CITY OF FORT LAUDERDALE

# DEVELOPMENT REVIEW COMMITTEE

## CASE COMMENT REPORT

<b>CASE</b>	UDP-S25010
<b>PROJECT NAME</b>	International Swimming Hall of Fame (ISHOF)
<b>APPLICATION TYPE</b>	Site Plan Level IV Request
<b>APPROVAL LEVEL</b>	DRC, Planning and Zoning Board Review, City Commission approval
<b>REQUEST</b>	New 220,120 square foot, 6-story building containing 31,394 Square Foot Office Use, 29,377 Square Foot Event Space, 18,512 Square Foot Museum, and 18,254 Square Foot Aquarium with an associated parking reduction request.
<b>APPLICANT</b>	City of Fort Lauderdale
<b>AGENT</b>	Stephanie Toothaker, Esq., P.A.
<b>PROPERTY ADDRESS</b>	501 Seabreeze Blvd.
<b>ABBREVIATED LEGAL DESCRIPTION</b>	International Swimming Hall of Fame Complex 138-19 B Parcel "A"
<b>ZONING DISTRICT</b>	South Beach Marina and Hotel Area District (SBMHA)
<b>LAND USE</b>	Central Beach Regional Activity Center
<b>COMMISSION DISTRICT</b>	2 – Steven Glassman
<b>NEIGHBORHOOD ASSOCIATION</b>	Central Beach Alliance HOA

CC Presentation - South Elevation

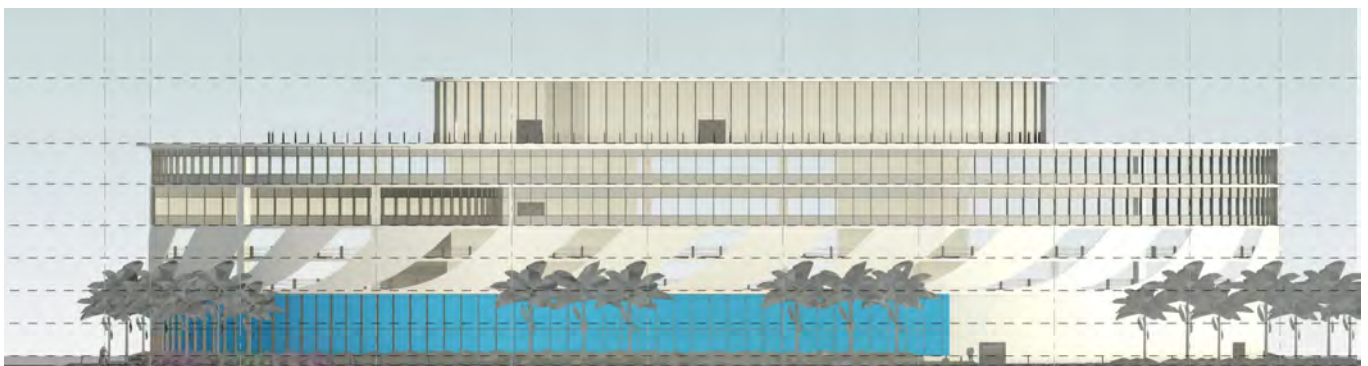
- 18. Overall, the building is massive in nature, lacks articulation, verticality, and visual interest. In addition, the submitted plans for the proposed west building does not match the building design as presented to the City Commission (CC) on March 4, 2025. The building presented at the March 4, 2025, CC meeting appeared less massive, a smaller footprint, and incorporates cutouts and areas of respite throughout the building which provided views from the south and west, specifically on the 4<sup>th</sup> and 5<sup>th</sup> floor. The submitted plans removed all the cutouts to the building, has a larger footprint, and has enclosed the areas of respite throughout the building. In addition, the pedestrian access/promenade also appears to have been reduced.

The building design should reflect the design presented to the CC and blend with the surrounding context with exceptional transparency for the active levels, including the area with VIP bleachers on the second floor and regular seating on the ground floor in order for spectators to view swimming and other events. Furthermore, the west building should also incorporate a similar curved roof line as the existing buildings on the site to maintain a more cohesive project. The project should take advantage of the views of the intracoastal and reduce any obstruction, especially the site line when entering the site from Seabreeze Boulevard. The parking levels should be screened with exceptional architectural solutions that provide variation in form and material given the large surface areas of the parking garage façade as well as adequately screen interior lighting and mitigate noise pollution. Given the location and visibility of the project, the garage screening should be creative in design and contain unique illumination at night. Special consideration should be taken to ensure the screening material can withstand the elements such as high winds and salt water. See below for comparison of project renderings from CC meeting to this application submittal and also examples of screening materials
